ILLUSTRATED PARTS LIST LISTE DES PIÉCES

T720

**POWER TILLER
MOTOCULTEUR**

97898-40430

2. CLAPET BREATHER GROUP

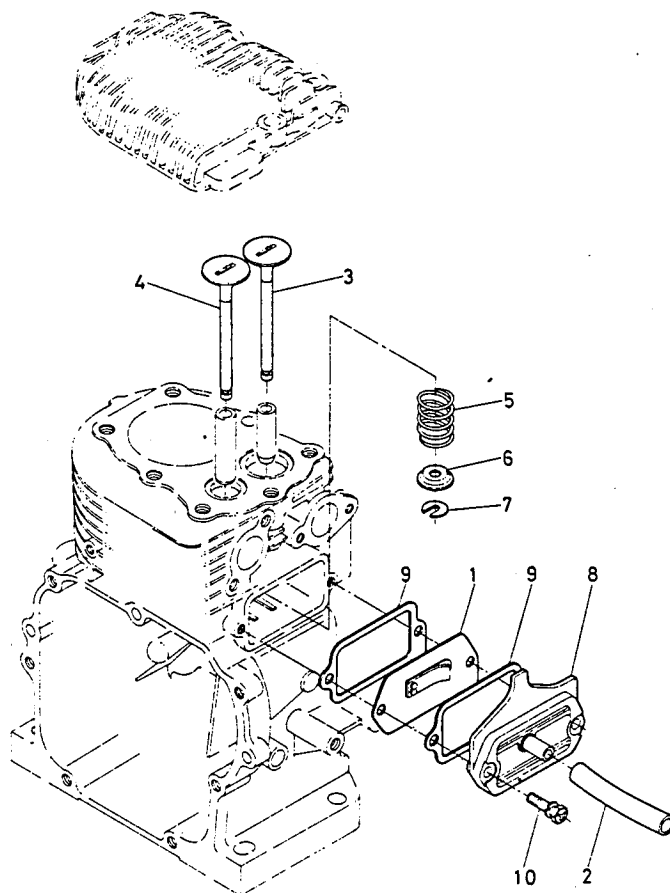
REF. No. 3 13641-1311-2

$$\begin{aligned} \ell_1 &: 96.5 \rightarrow 96.3 \text{ mm} \\ \ell_2 &: 101.5 \rightarrow 101.3 \text{ mm} \\ \ell_3 &: 103.2 \rightarrow 103 \text{ mm} \end{aligned}$$

REF. No. ④ 13641-1312-2

$$\begin{aligned} \ell_1 &: 96.5 \rightarrow 96.3 \text{ mm} \\ \ell_2 &: 101.5 \rightarrow 101.3 \text{ mm} \\ \ell_3 &: 103.7 \rightarrow 103.5 \text{ mm} \end{aligned}$$
[illegible]

3. FILTRE A AIR AIR CLEANER GROUP

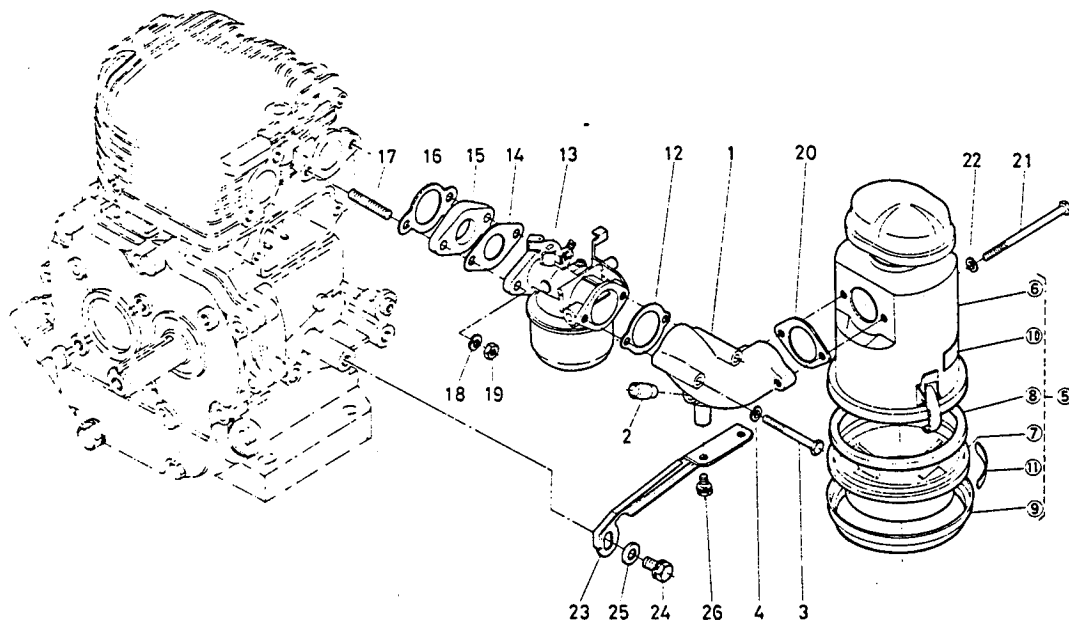
- Changed the choke valve.
(shown page 12)

5. ARBRE A CAME CAMSHAFT GROUP

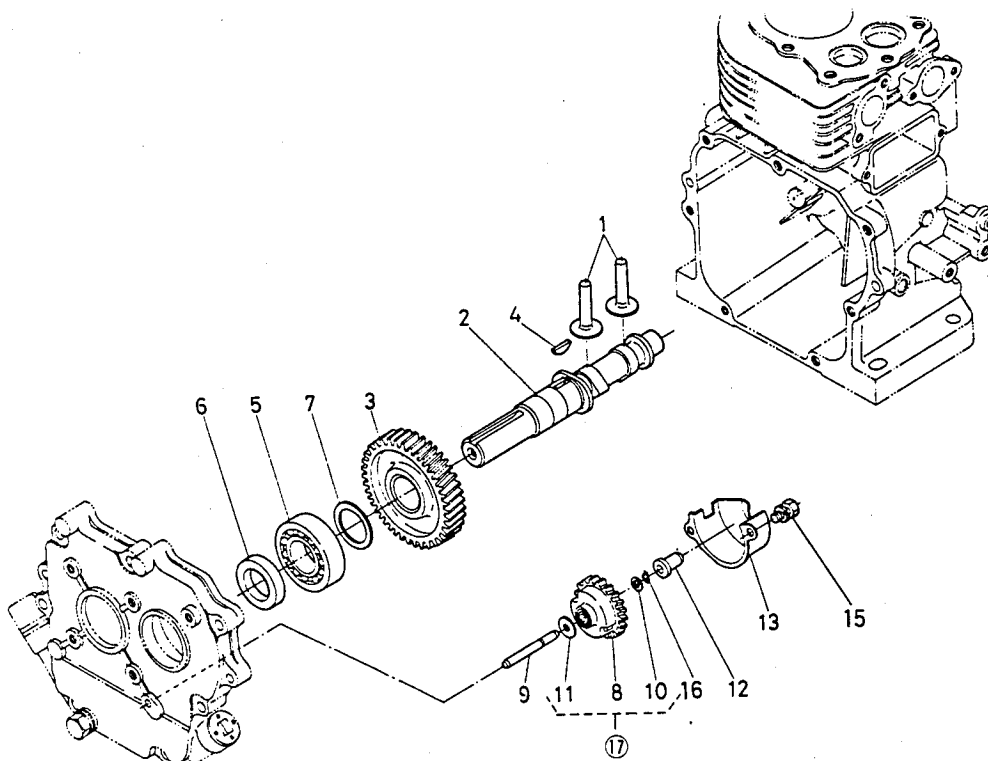
REF. No. 3 13641-1651-6

l_1 : 32.2 - 31.8 mm
 l_2 : 6 - 5.5 mm

REF. No. 3 13641-9523-1

l : 6.5 - 6.1 mm

REF. No. 3 13641-5535-4

l : 26 - 29 mm

6. VILEBREQUIN CRANKSHAFT GROUP

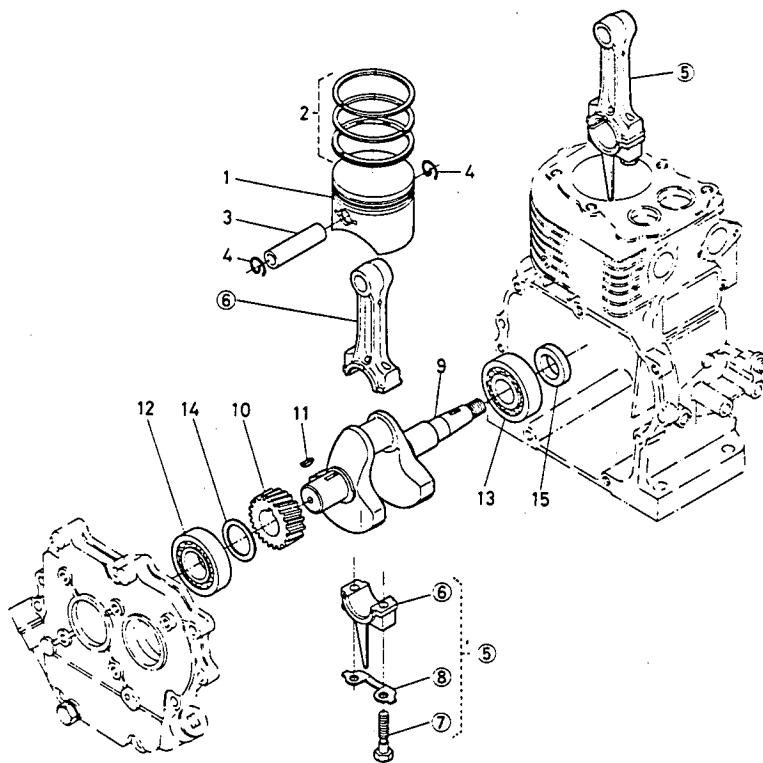
REF. No. 13641-2411-5

$l: 32.2 \rightarrow 31.8 \text{ mm}$

REF. No. JI 13641-9523-1

$\ell: 6.5 \rightarrow 6.1 \text{ mm}$ [illegible]

7. FILTRE ET ROBINET ESSENCE FUEL FILTER GROUP

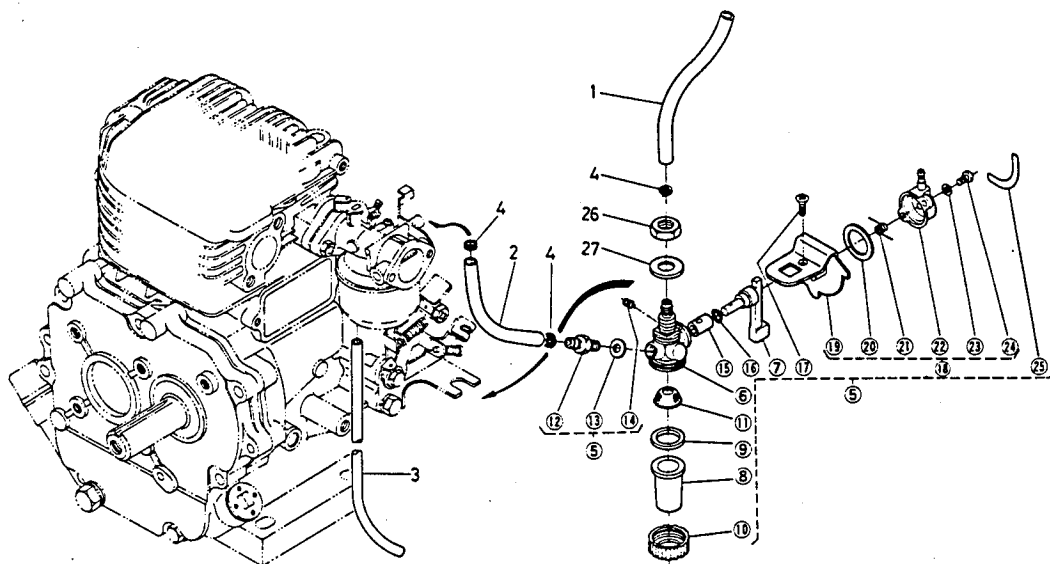
REF. No. ③ 13621-4236-1
• Diamètre intérieur
• Inner diameter
φ 10.3 → φ 10.8mm

REF. No. ③ 13641-4380-2
• Matière de la prise de courant
• Material of the terminal
ZDC2 →BSBM

8. REGULATEUR LEVIER GOVERNOR LEVER GROUP

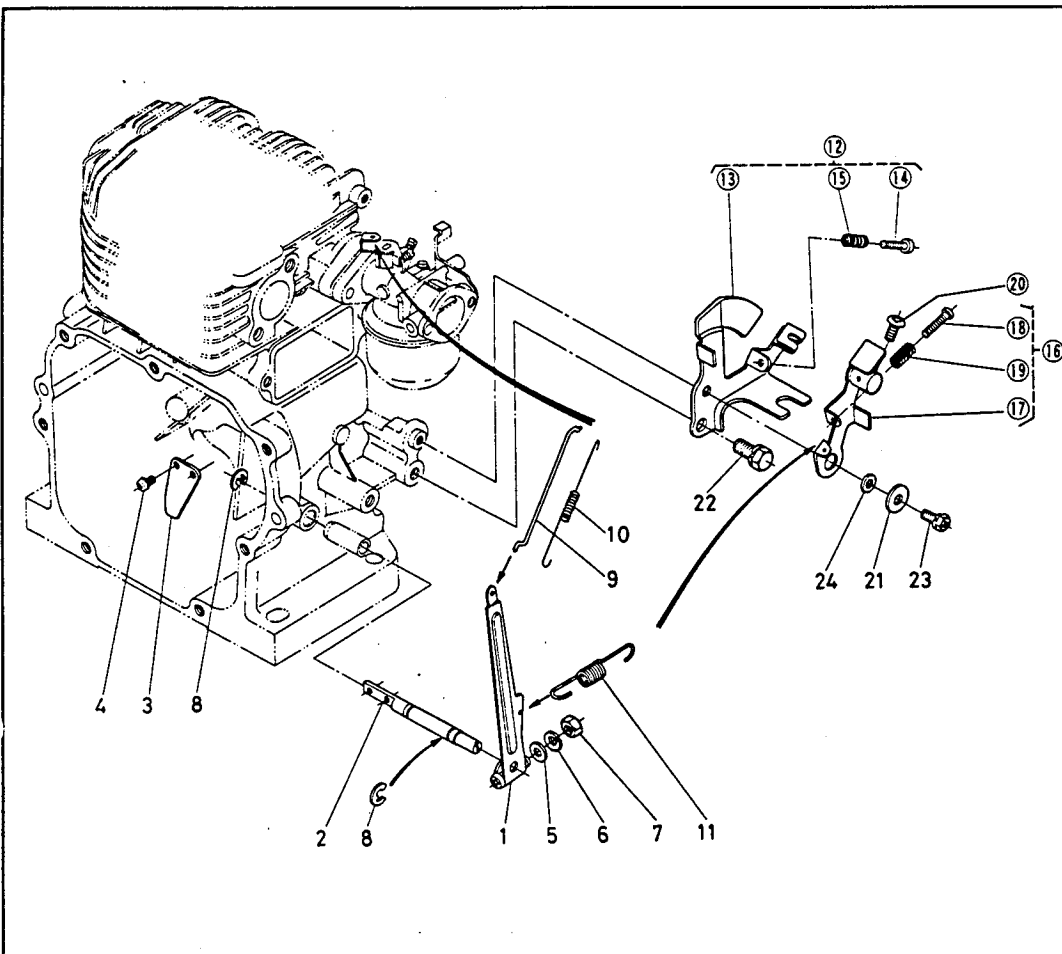
REF. No. 2 13641-5614-3

REF. No. 13 13641-5711-5

- Renforcé
- Reinforced

REF. No. 13 13316-9341-1

REF. No. 13 13581-9341-1

20-25mm

REF. No. 13 13641-5686-1

- Longueur
- Length

15-19mm

12. CARBURATEUR CARBURETTOR GROUP

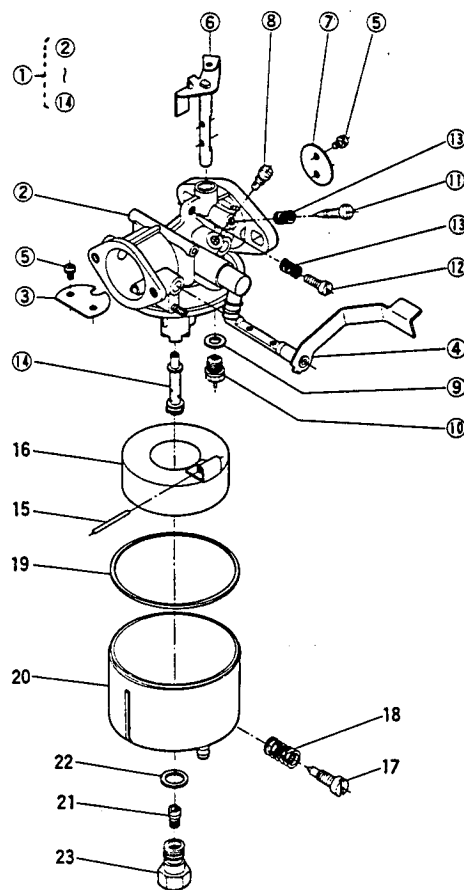
REF. No. ① 13644 - 44021

REF. No. ③ 13641-44532

$l: 7 \rightarrow 8.5 \text{ mm}$ [illegible]

13. BOITE DE VITESSES TRANSMISSION GROUP

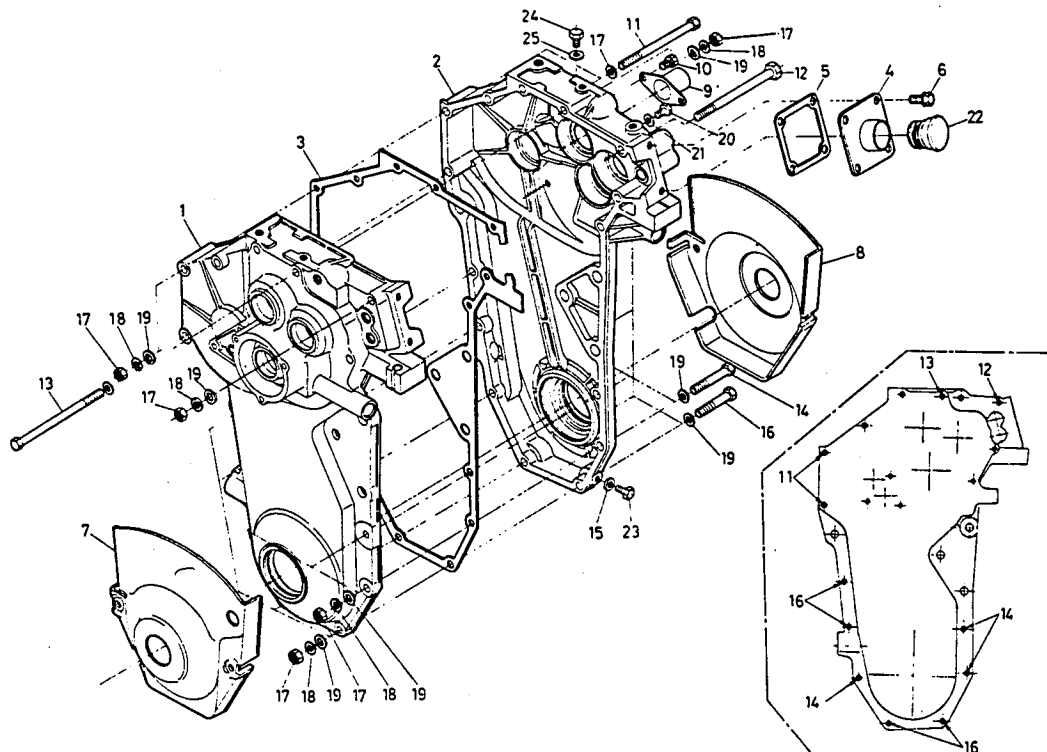
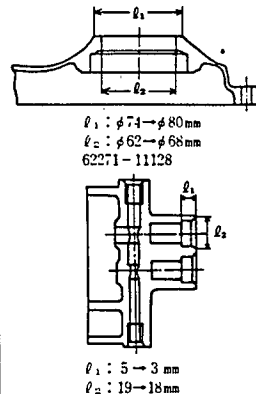
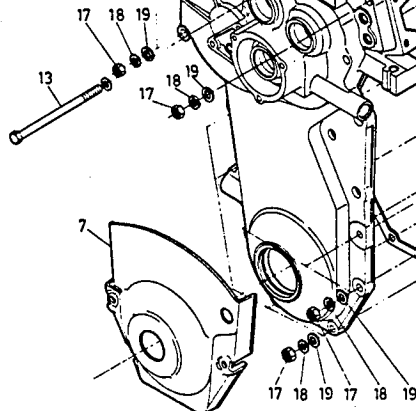
REF. No. 1 62271-11114
• Renforcé et changé en forme.
• Reinforced and changed in shape.
62271-11117

REF. No. 2 62271-11120
• Renforcé et changé en forme.
• Reinforced and changed in shape.
62271-11127

$l_1: \phi 62 \rightarrow \phi 68 \text{mm}$
 $l_2: \phi 74 \rightarrow 80 \text{mm}$

$L_1: \phi 74 \rightarrow \phi 80\text{mm}$
 $L_2: \phi 62 \rightarrow \phi 68\text{mm}$
 62271-11128

$l: 76-82\text{mm}$

14. POIGNEE DEPORT
MAIN CLUTCH GROUP

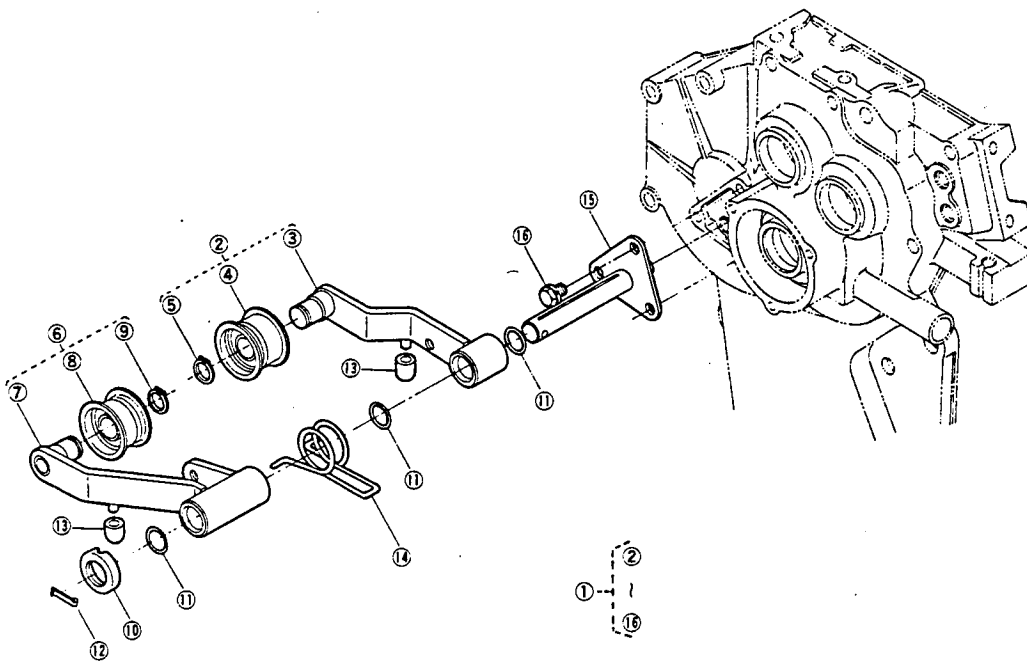
REF. No. 62271-1331-3

d : $\phi 10 \rightarrow \phi 14 \text{ mm}$
 ℓ : 7 mm

15. BOITE DE VITESSES
MISSION GEAR GROUP

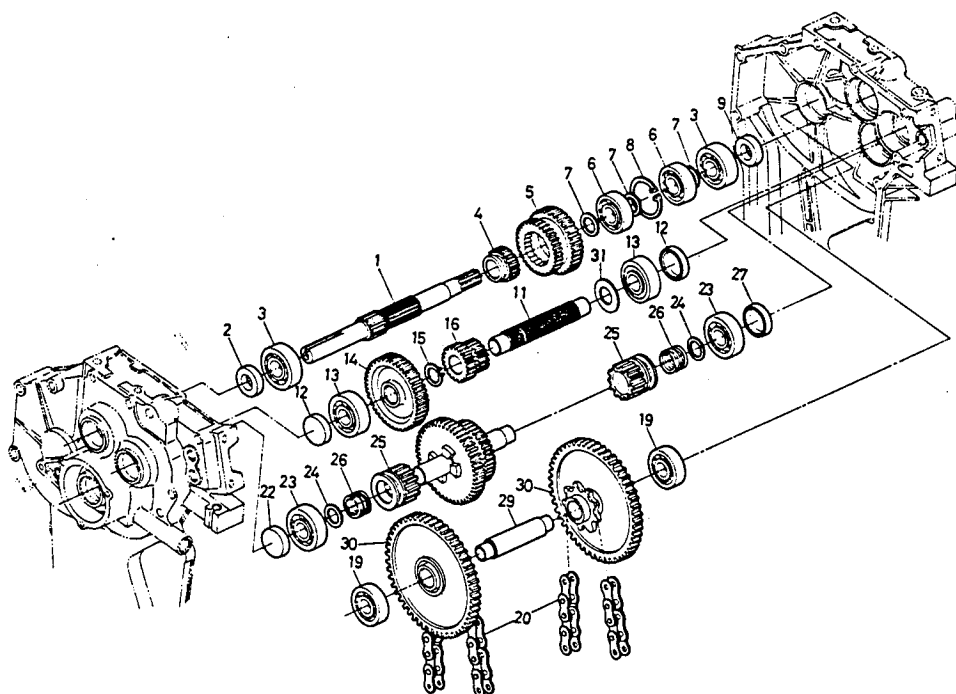
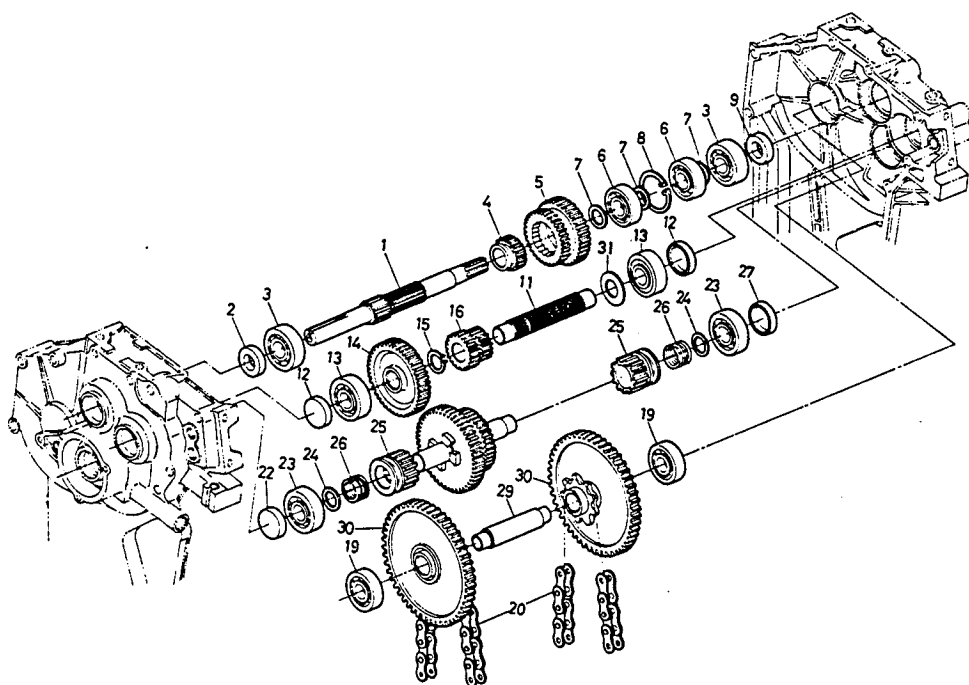
REF. No. 62271-1421-2

$$\begin{aligned} \ell_1 &: 87.4 \rightarrow 85.4 \text{ mm} \\ \ell_2 &: 106 \rightarrow 104 \text{ mm} \\ \ell_3 &: 15 \rightarrow 17 \text{ mm} \end{aligned}$$

REF. No. 62271-1430-2

$$\theta: 5^\circ \rightarrow 18.5^\circ$$
[illegible]

16. AXE HEXAGONAL WHEEL GROUP

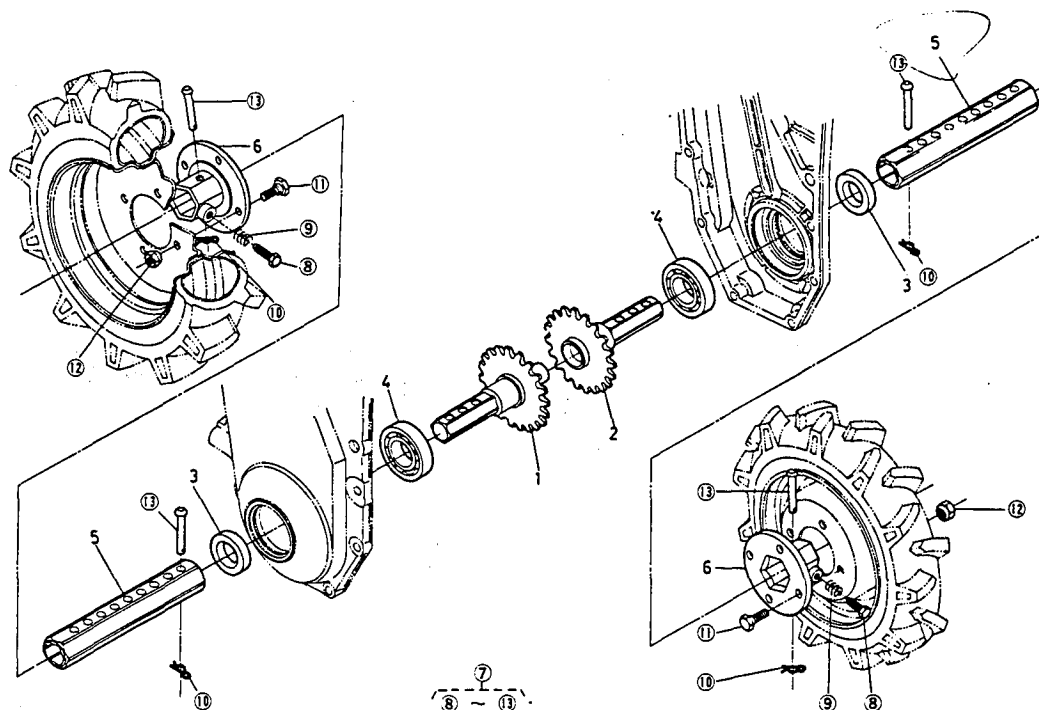
REF.No. ② 62271-1720-3
• Matière de le pignon de chaîne
• Material of the sprocket wheel
S43C → SCM21

REF.No. ③ 62271-1719-1
• Diamètre extérieur
• Outside diameter
φ62 → φ68mm

17. CHANGEMENT 1
CHANGE GROUP 1

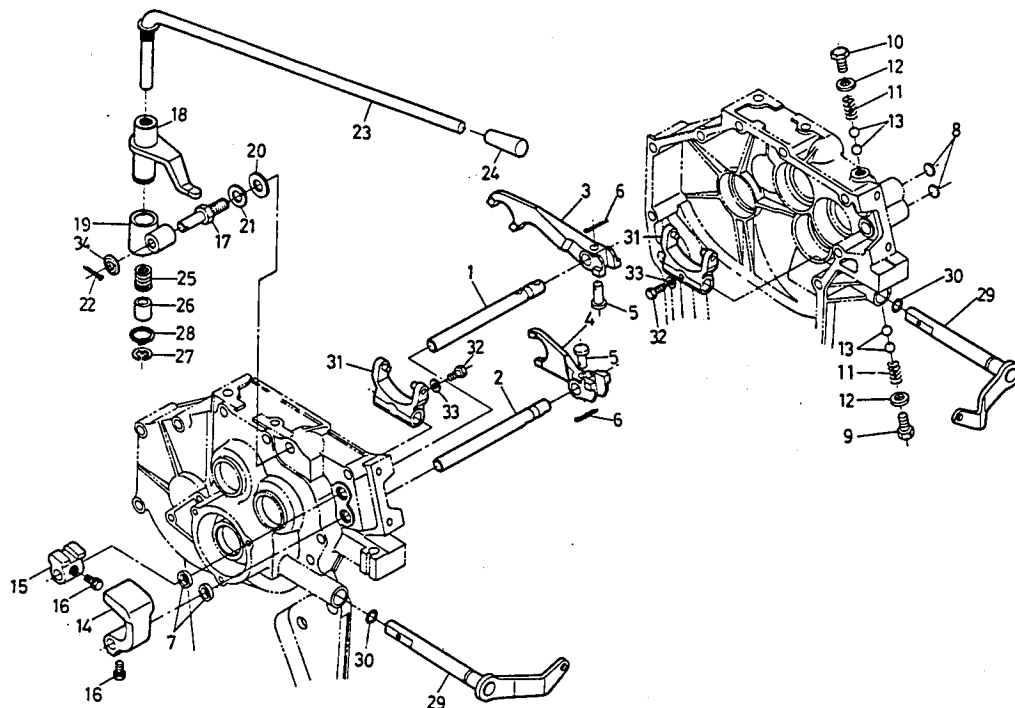
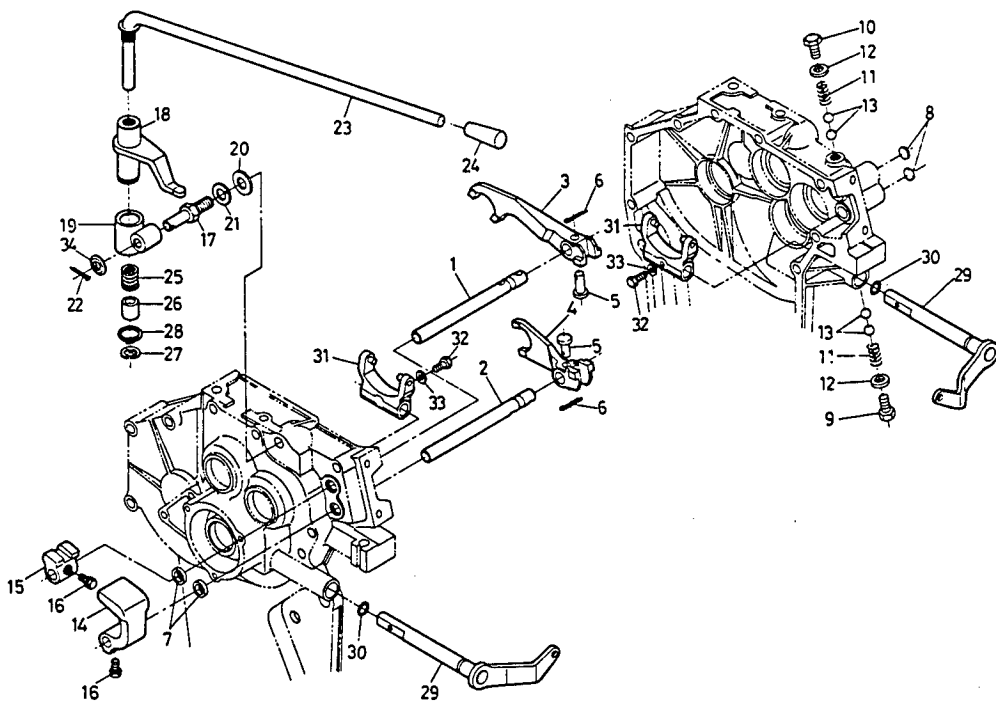
REF. No. 8
62271-1826-1 06311-75018

REF. No. 62271-1831-2

$$\begin{aligned} \ell_1 &: 34 \rightarrow 36 \text{ mm} \\ \ell_2 &: 17 \rightarrow 19 \text{ mm} \\ \ell_3 &: 6.5 \rightarrow 7 \text{ mm} \\ \ell_4 &: 48 \rightarrow 47.5 \text{ mm} \end{aligned}$$

REF. No. ⑮ 62271-1832-2

$$\begin{aligned} \ell_1 &: 34 \rightarrow 38 \text{ mm} \\ \ell_2 &: 17 \rightarrow 19 \text{ mm} \\ \ell_3 &: 21 \rightarrow 21.5 \text{ mm} \\ \ell_4 &: 6.5 \rightarrow 7 \text{ mm} \end{aligned}$$
[illegible]
